UNITED STATES
NUCLEAR REGULATORY COMMISSION

SUBJECT: ISSUANCE OF AMENDMENT NO. 48 TO FACILITY OPERATING LICENSE NPF-18
LASALLE COUNTY STATION, UNIT 2 (TAC NO. 62832)

This amendment revises the LaSalle County Station, Unit 2 Technical Specifications to allow use of high density fuel racks in Unit 2.

FIGURE 7

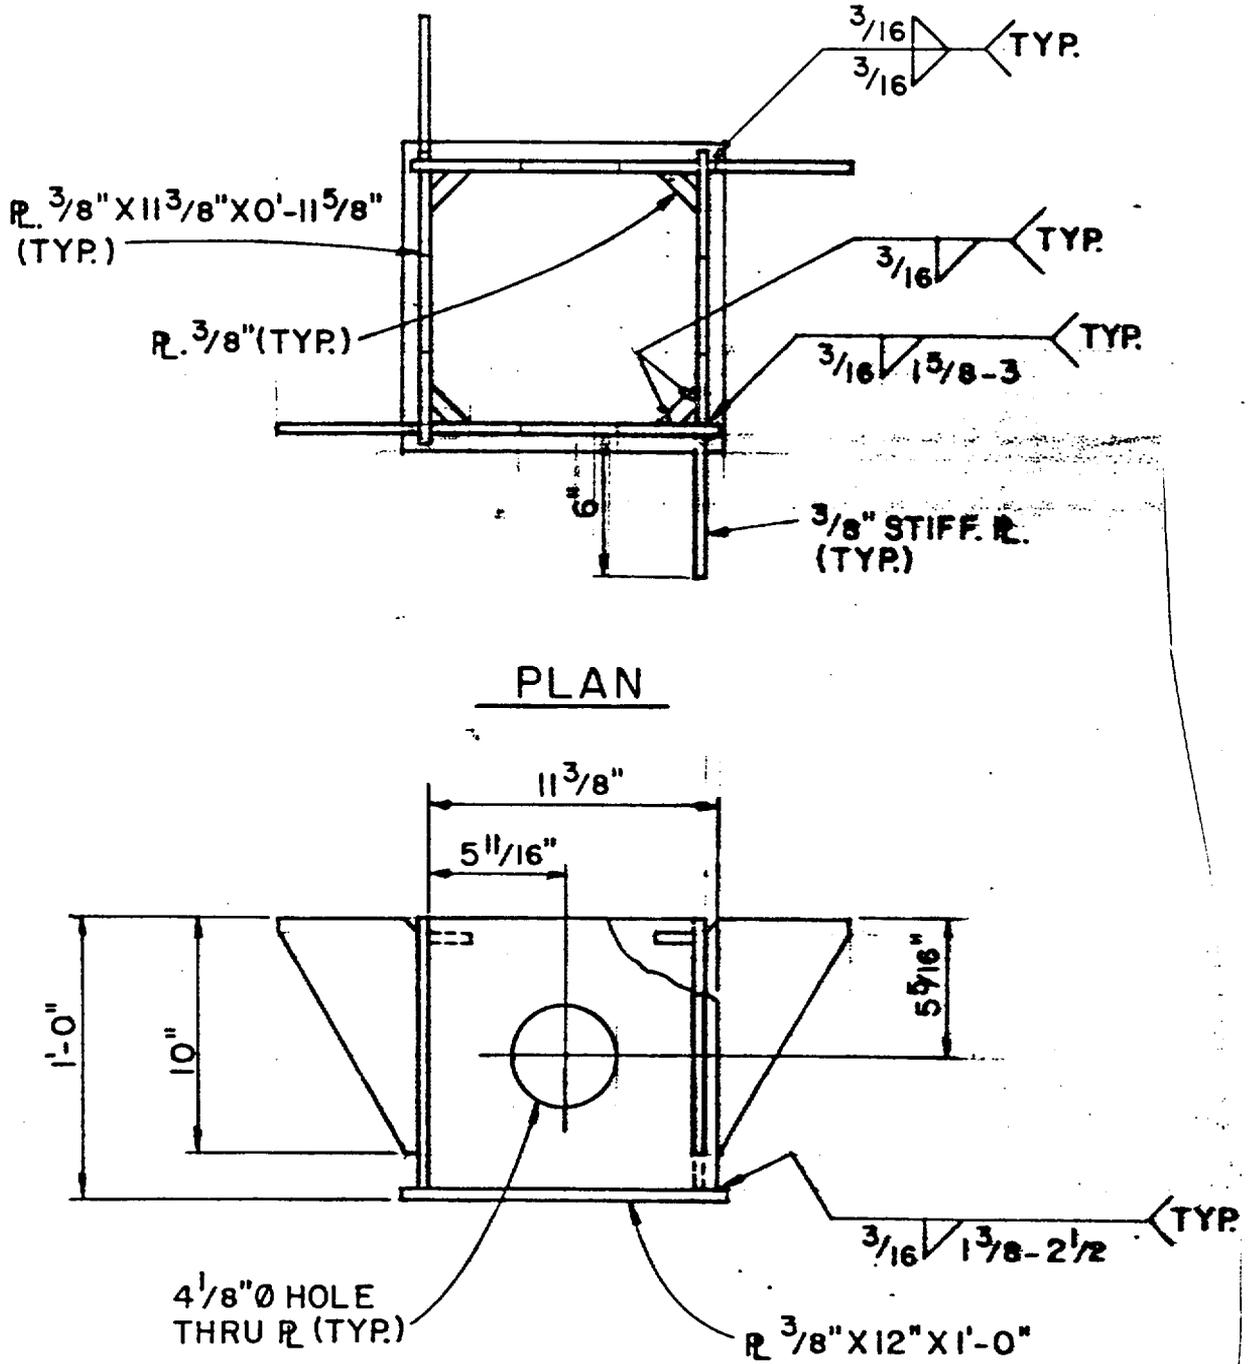
The replacement high density spent fuel racks will rest on bridge plates (Figure 7) on the pool floor. The bridge baseplates span seam welds on the pool floor. The bridge plates are not attached to the pool floor but have collars which engage the feet they support. The baseplates were not included in the rack model but were assumed to move with the rack. The baseplates are large enough to accommodate the possible slippage of the fuel racks during an earthquake without coming in contact with the liner seams.

FIGURE 14

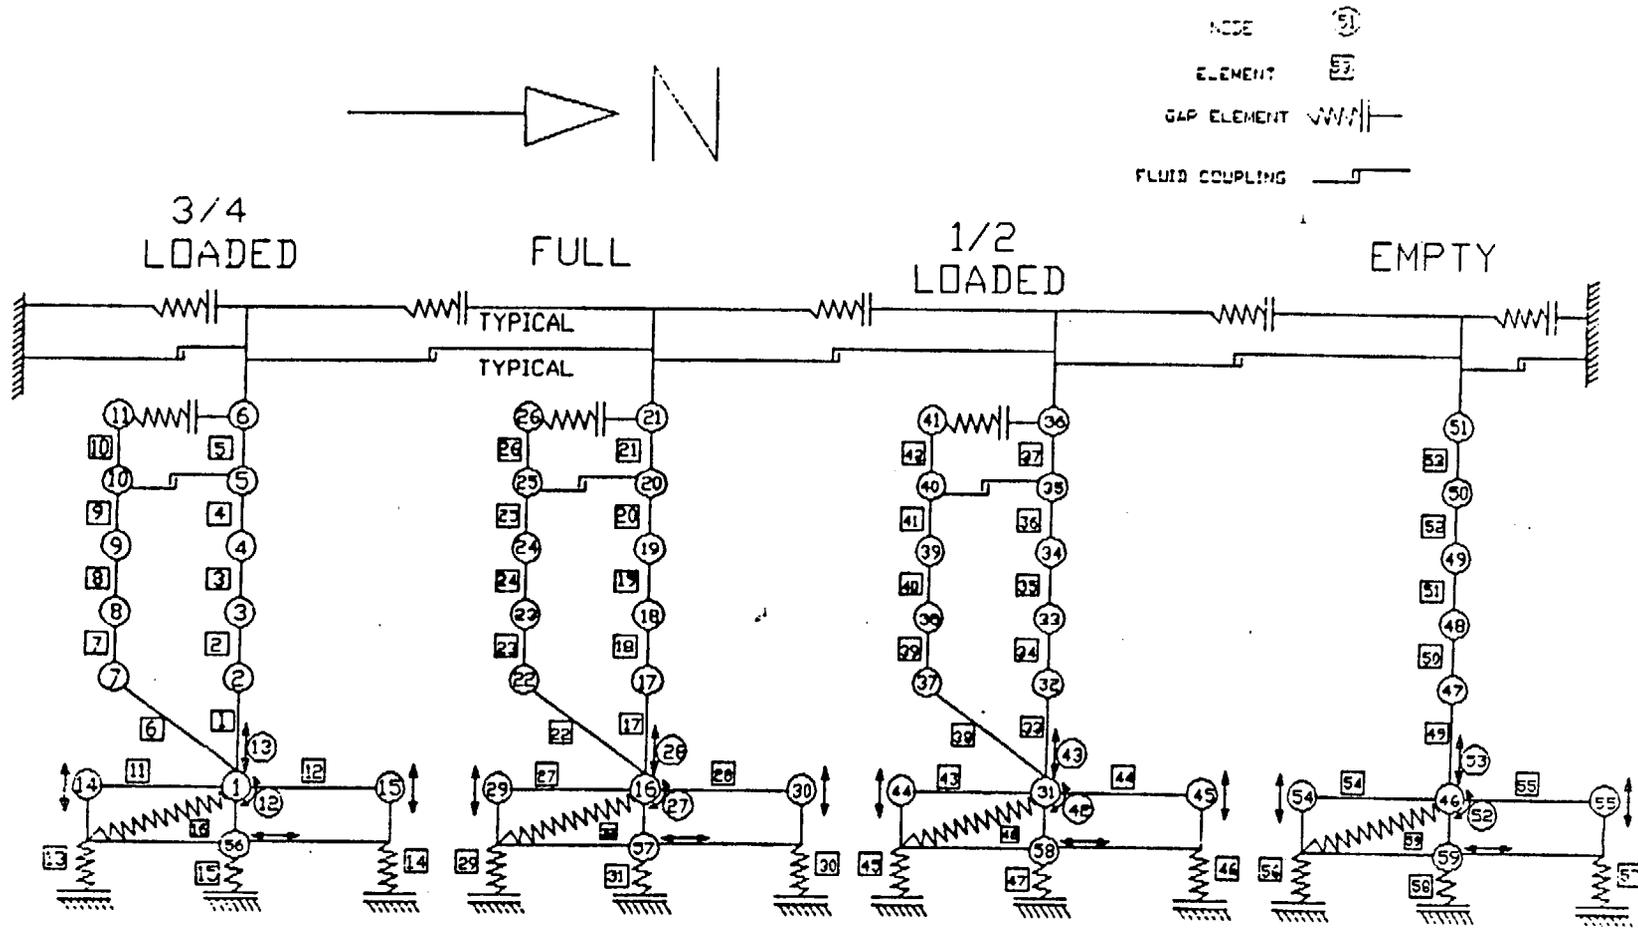
The 2-D multi-rack model shown in Figure 14 was analyzed with the RACKOE computer program, which was developed and verified by U.S. Tool and Die (UST&D). The analysis was performed for the combination of SSE and SRV since the higher seismic level will control the dynamic response. The North-South time history and the vertical time history were applied simultaneously. These time histories are the same as those utilized for the initial 3-D single rack analysis (see section 4.1.5).

The impact forces for the multi-rack analysis were much smaller than the forces from the initial 3-D analysis and the refined 3-D analysis. This is probably due to having only a 2-D model and 2-D input time history. The addition of the third input simultaneously, would increase the response, particularly if tilting occurs about both horizontal axes thereby causing torsional rotation about the vertical axis as well.

A review of the displacement time history response did show movement for all four racks in the North direction until impact with the North wall occurred. In addition, the motion of the three racks having partial and full fuel assemblies were very similar indicating strong hydrodynamic coupling effects while the empty rack motion was more erratic with very little correlation to the other three rack motions.

FIGURE 16

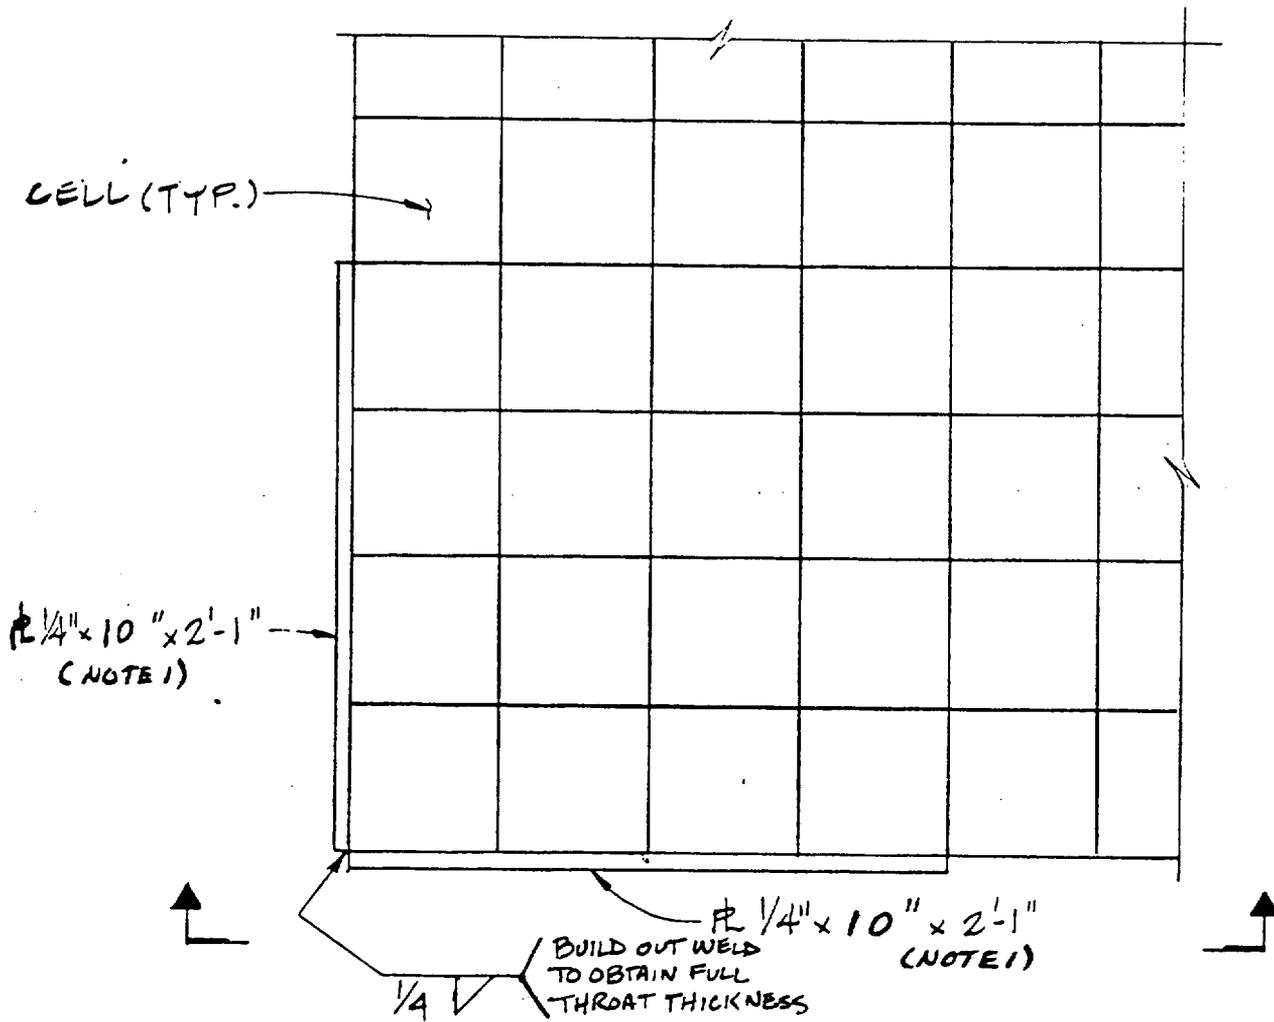
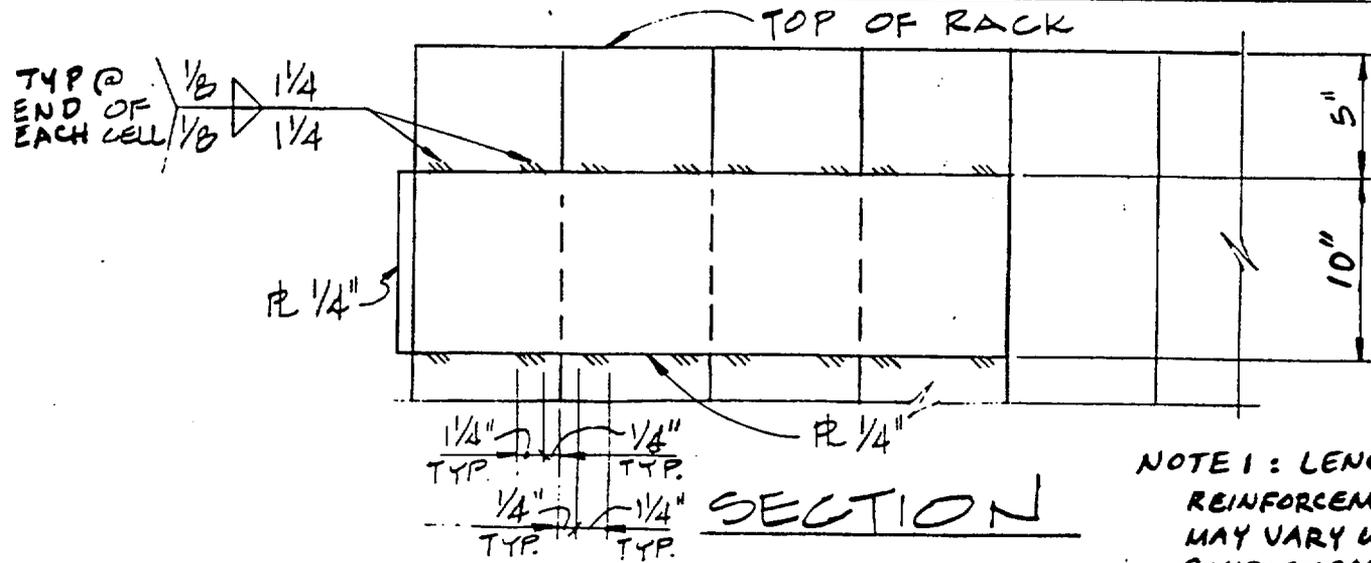
The rack to wall impact was judged to be more critical for the rack adequacy than the rack to rack impact since there is more flexibility in impacts between two racks. A detailed 2-D model representing the cells near the top of the rack was developed to analyze the local effects of the impact force. This model is shown in Figure 15. As a result of this analysis, the compressive stresses in some cell walls exceeded the allowable buckling stress. Thus, the Licensee proposed to install reinforcement plates as shown in Figure 16, to distribute the impact force over a sufficient number of cells where the compressive stresses are low enough.

With the addition of the 1/4" thick reinforcement plates as shown on Figure 16, the impact capacity of the racks has been demonstrated to be acceptable.
